Field Repair Work Instruction No. FRWI - 517	Rev. NR	Page 1 of 2
	Remove “Hopkins Electronic Taillight Converter Harness” from Chassis and Replace with Part # 04101971		
Identify Process Owner: Warranty, Product Engineering		Document Control Administrator: Quality Department

Field Repair Work Instruction No. FRWI-517	Rev. NR	Page 2 of 2
	Remove “Hopkins Electronic Taillight Converter” from Chassis Harness

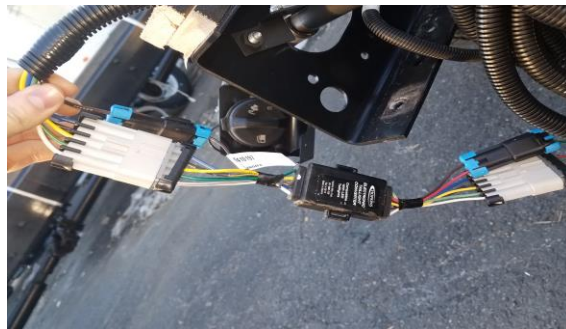
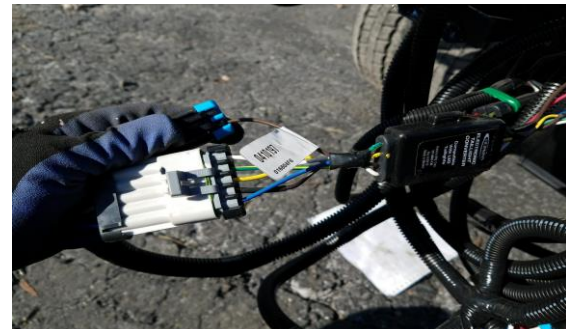
3.0	STEP 2: Removing and Replacing Harnesses Part A: Locating the converter Harness This part is a small black plastic module with “Hopkins Electronic Taillight Converter” marked on one side. Converter will be a plug n play harness, -identifiable with Metri-Pac connectors at both ends and will be located between the chassis cab and the taillight harness (typically found inside Chassis Frame rail at rear). Part B: Replace Converter harness with Morgan supplied harness Disconnect Metri-Pac connectors at each end to remove converter harness from vehicle Reconnect Metri-Pac connectors and tug on each connection to ensure a secured fit** Re-secure harness with wire ties to original location Confirm that Lights are operational and compliant to FMVSS-108.
